Tennessee Valley Authority, Post Office Box 2000, Decatur, Alabama 35609-2000

BROWNS FERRY NUCLEAR PLANT (BFN) - TVA RESPONSES TO NRC REQUESTS FOR ADDITIONAL INFORMATION (RAI) REGARDING UNITS 2 AND 3 - TECHNICAL SPECIFICATIONS (TS) CHANGE NO. 414 - PRESSURE - TEMPERATURE (P-T) CURVE UPDATE

PROPOSED TECHNICAL SPECIFICATIONS (TS) CHANGE TS-414 SUPPLEMENT 1
DESCRIPTION AND EVALUATION OF THE PROPOSED CHANGE

PROPOSED TECHNICAL SPECIFICATION (TS) CHANGE TS-414 SUPPLEMENT 1
MARKED PAGES

Figure 3.4.9-1
Pressure/Temperature Limits

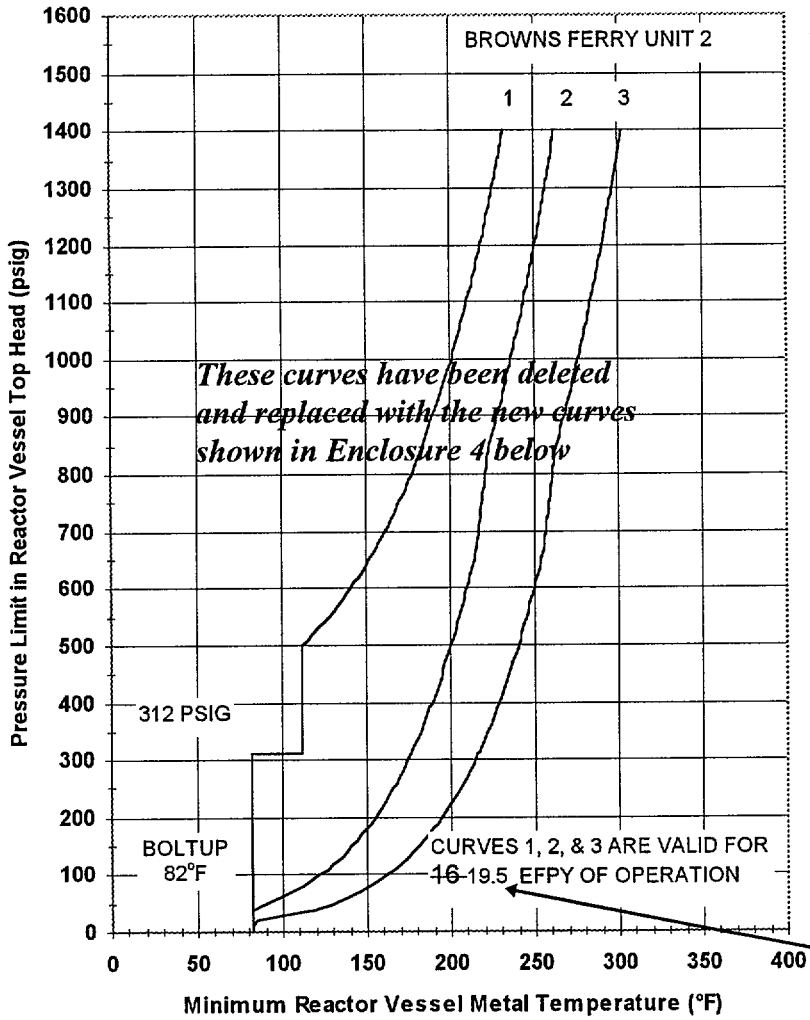
Added "ASME" for additional clarity in this note.

Notes
These curves include sufficient margin to provide protection against feedwater nozzle degradation. The curves allow for shifts in RT_{NDT} of the Reactor vessel beltline materials, in accordance with Reg. Guide 1.99, Rev. 2, to compensate for radiation embrittlement for ~~16~~ 19.5 EFPY.

The period of valid use of these curves has been changed from 16 to 19.5 EFPY.

Figure 3.4.9-1
Pressure/Temperature Limits

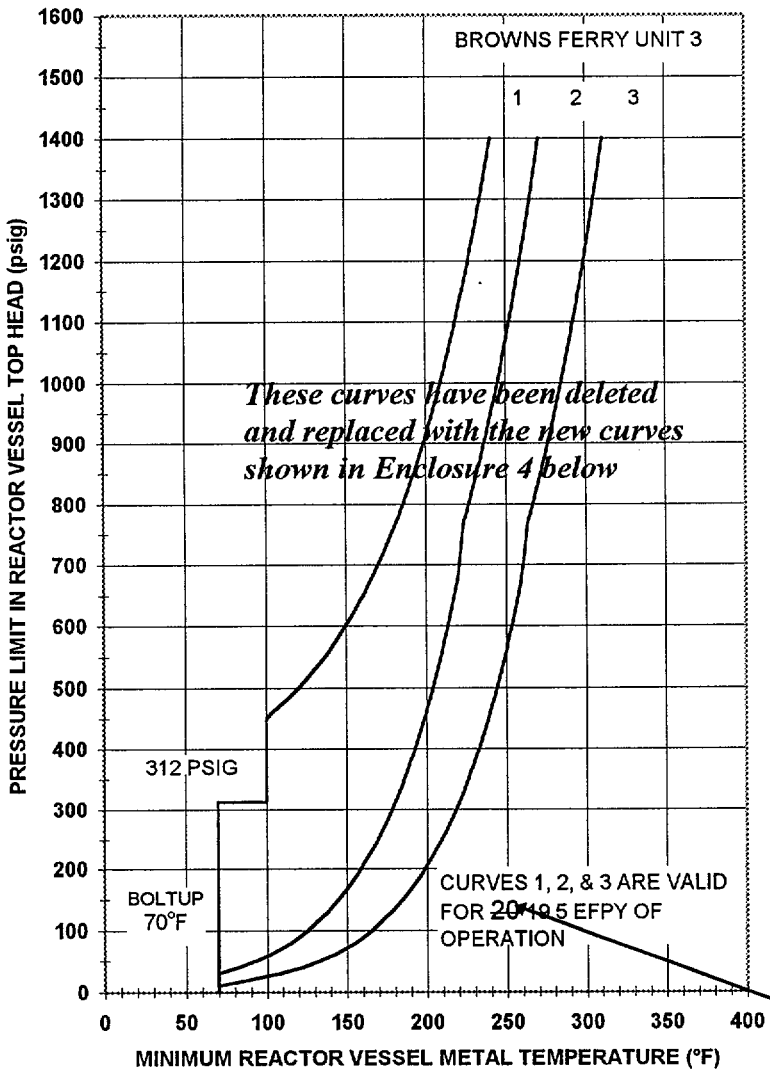
Added "ASME" for additional clarity in this note.

Notes
These curves include sufficient margin to provide protection againstfeedwater nozzle degradation. The curves allow for shifts in RT_{NDT} of the Reactor vesselbeltline materials, in accordance with Reg. Guide 1.99, Rev. 2, to compensate for radiation embrittlement for ~~20~~ 19.5 EFPY.

The period of valid use of these curves has been changed from 20 to 19.5 EFPY.

Figure 3.4.9-1
Pressure/Temperature Limits

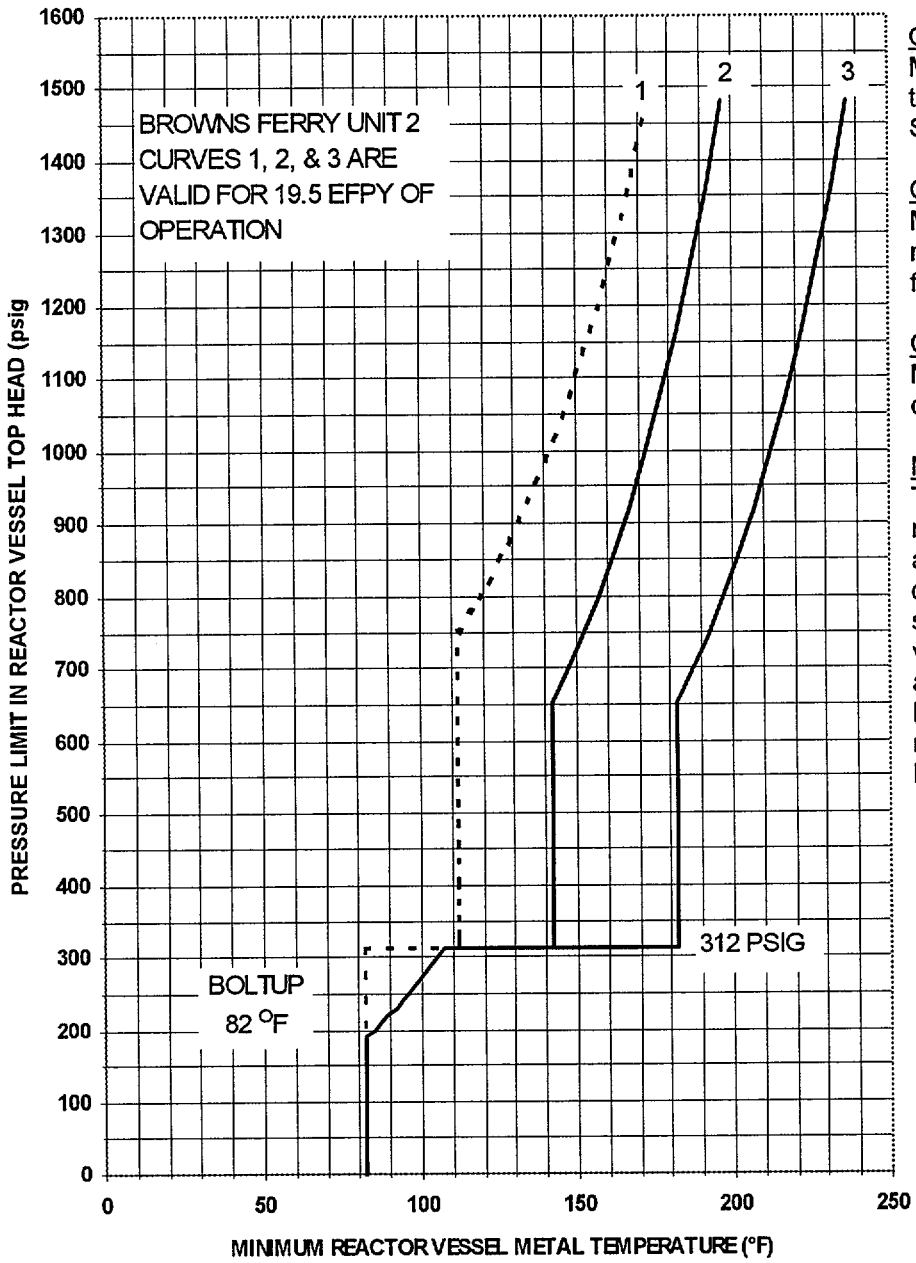
Note: these figures have been revised from those contained in TS-414 due to the change in the limiting ART from 102.9 °F to 110.6 °F.
